CURRENT CONDITION OF TOWNHOMES AT
OSAGE # 11 AND 12

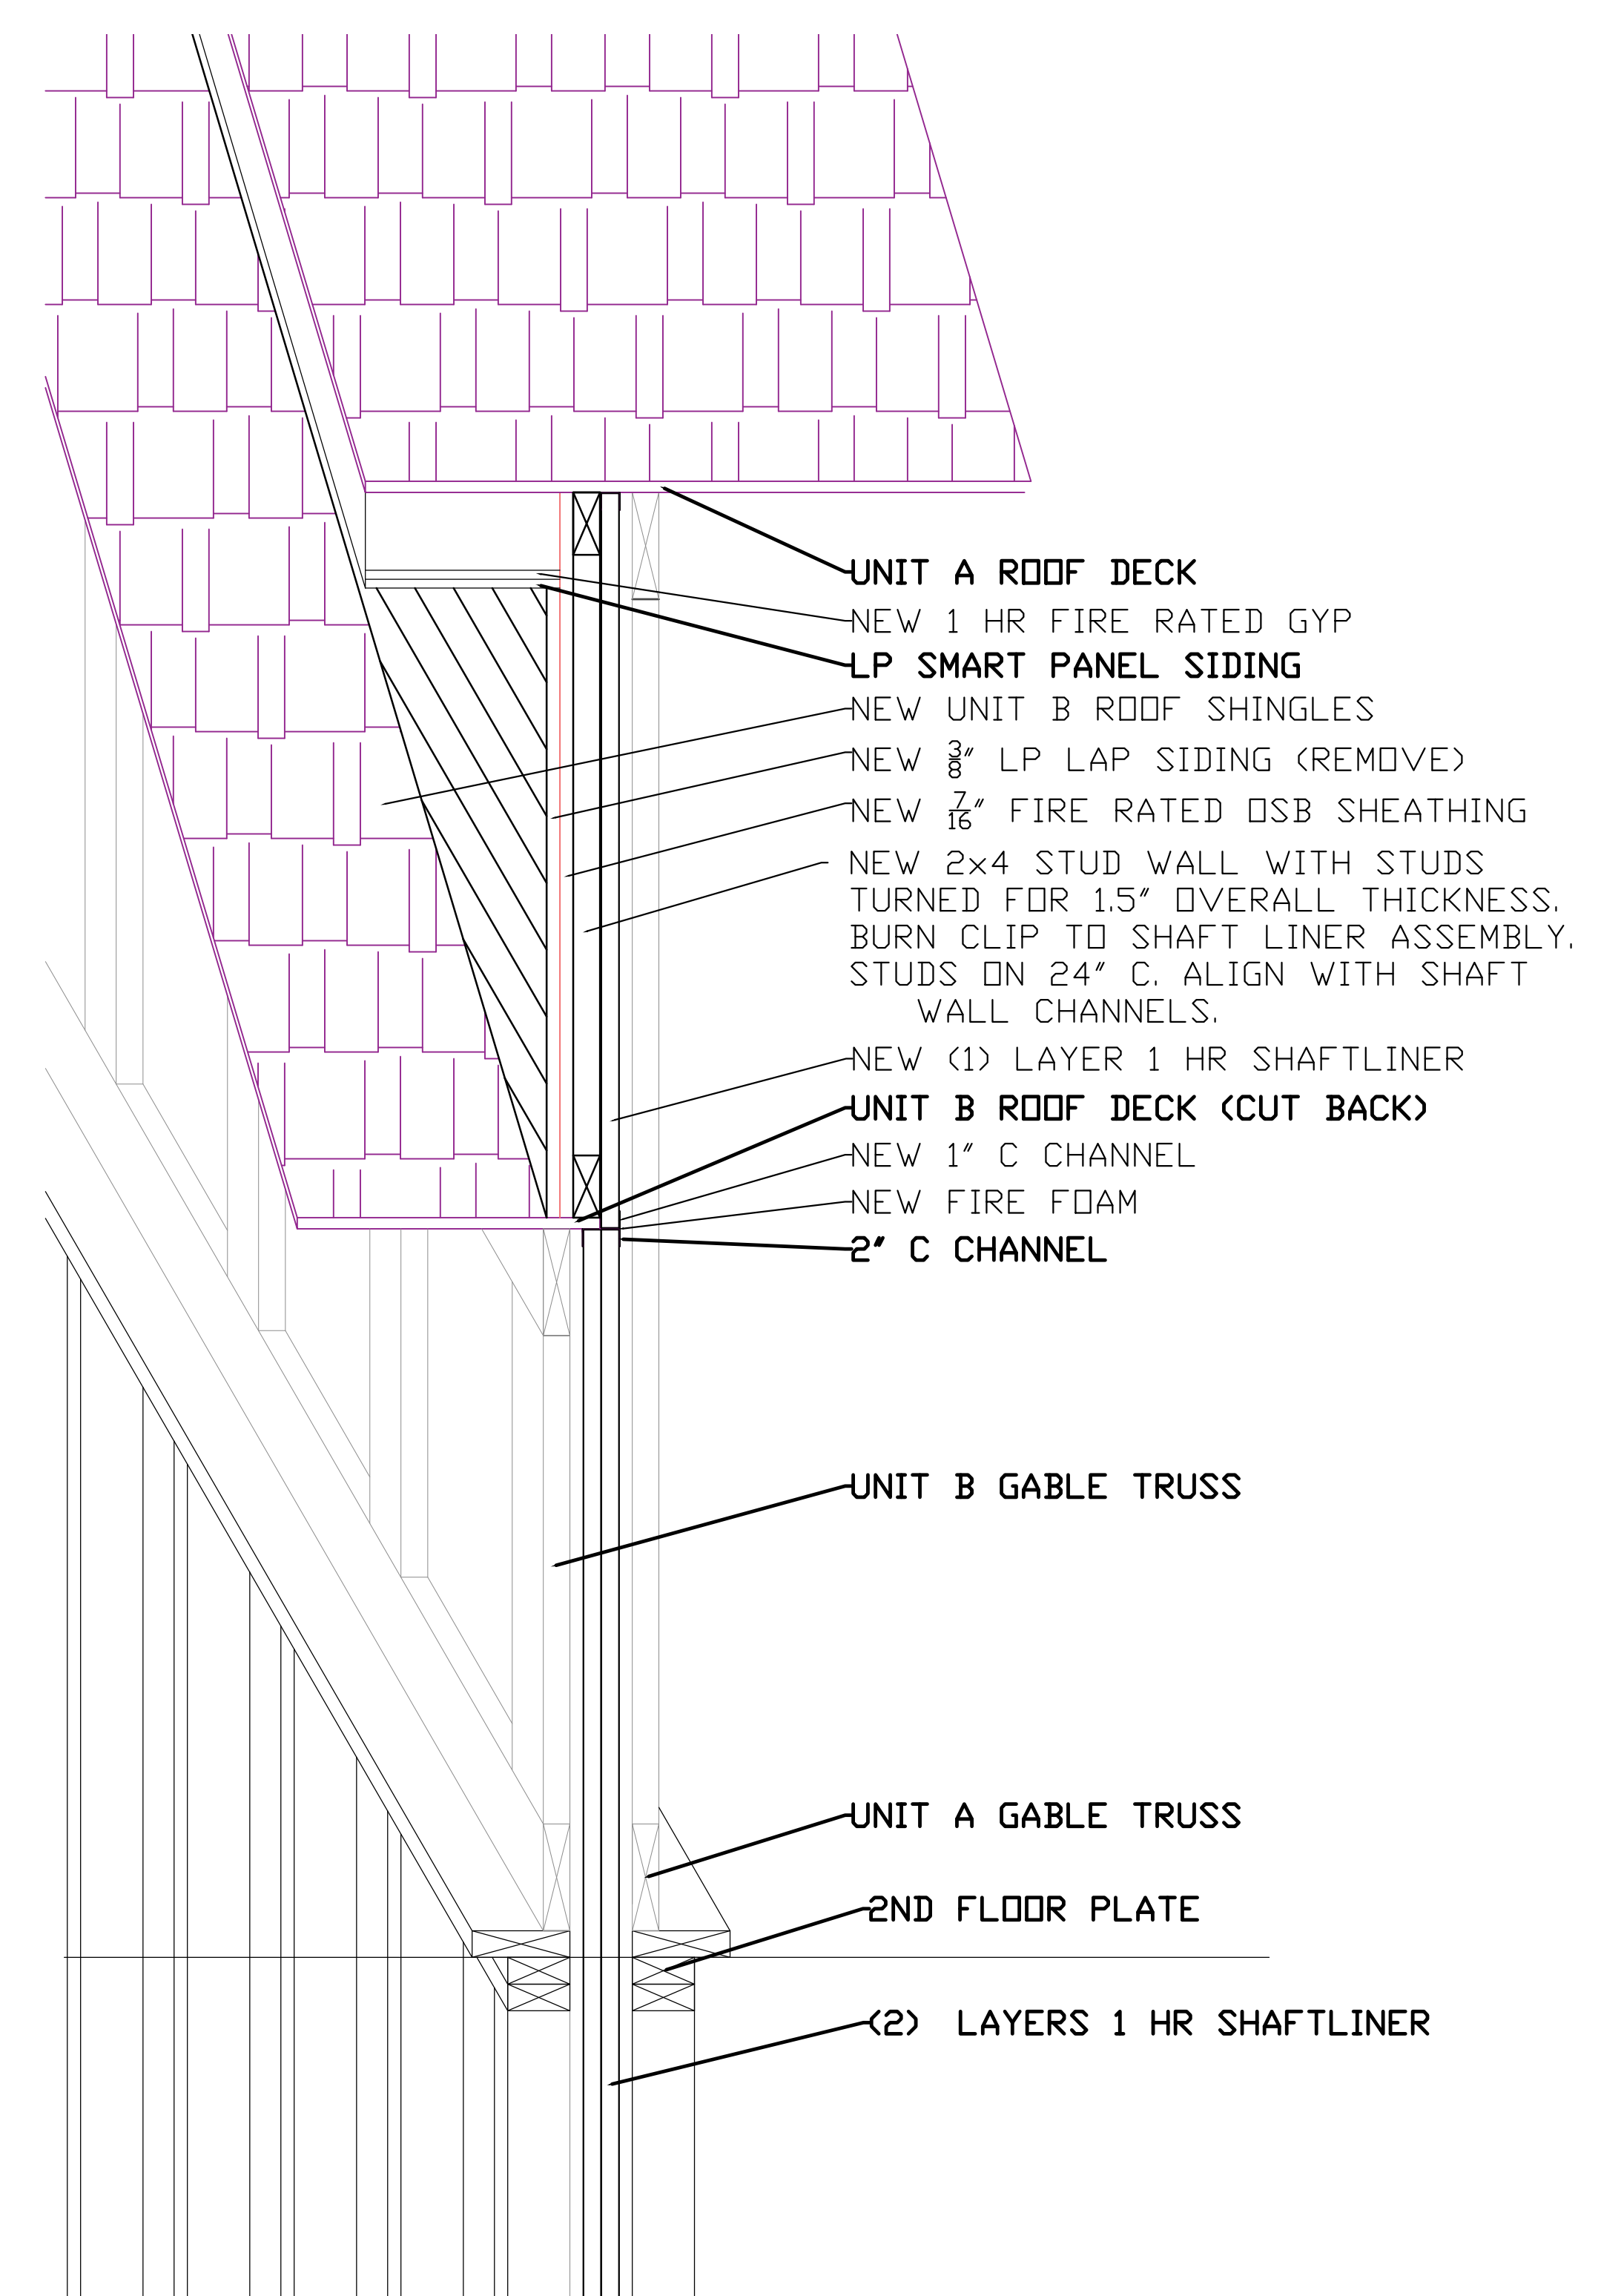
CORRECTIONS REQUIRED TO MEET R302.1(1)
AND R302.2 MAINTAINING 1 HR FIRE
PROTECTION PER UNIT FROM EITHER SIDE
THROUGH HEIGHT OF SEPARATION WALL AND
ADDING 1 HR PROTECTION FOR PROJECTIONS
BETWEEN UNITS.
